INSTRUCTIONS TO PERFORM RECALL CAMPAIGN 167

Certain Model Year Winnebago Certain 2021-2022 Inspire (Y34AE) Motorhomes.
These motorhomes were manufactured from May 17, 2021, through November 23, 2021.

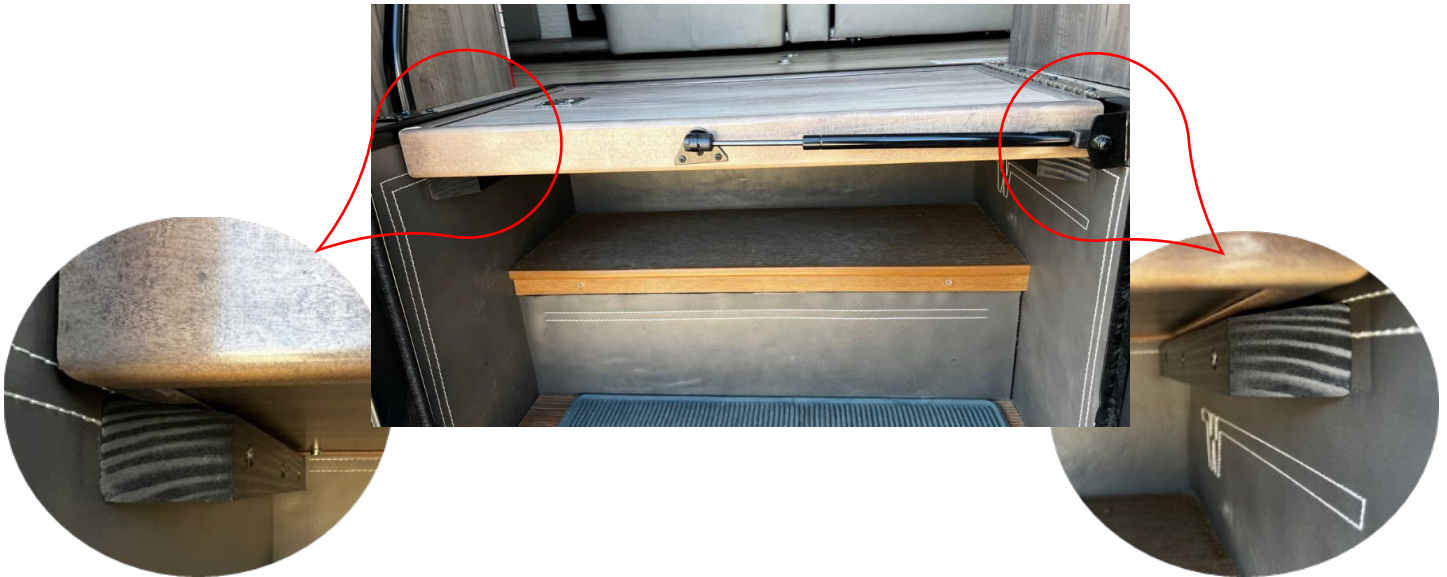
1. Remove screws that attach the two $\frac{3}{4}$ " step supports. Discard screws and step support sticks

2. Using silicone fill the open screw holes left after removing the $\frac{3}{4}$ " step support sticks.
3. Open recall kit RC7652-22-767 containing 2 - 1 $\frac{1}{2}$ " support sticks and the 6 fasteners.

4. Locate the 1 ½” support sticks from the kit, 2 ¼” from the top of the floor (see photo below). Ensure the chamfer edge of stick points towards the door opening.

5. Use the fasteners provided in kit and screw it in place. Repeat procedure on the for the other side.
6. After installation ensure the step overlaps the support sticks (see photo below)
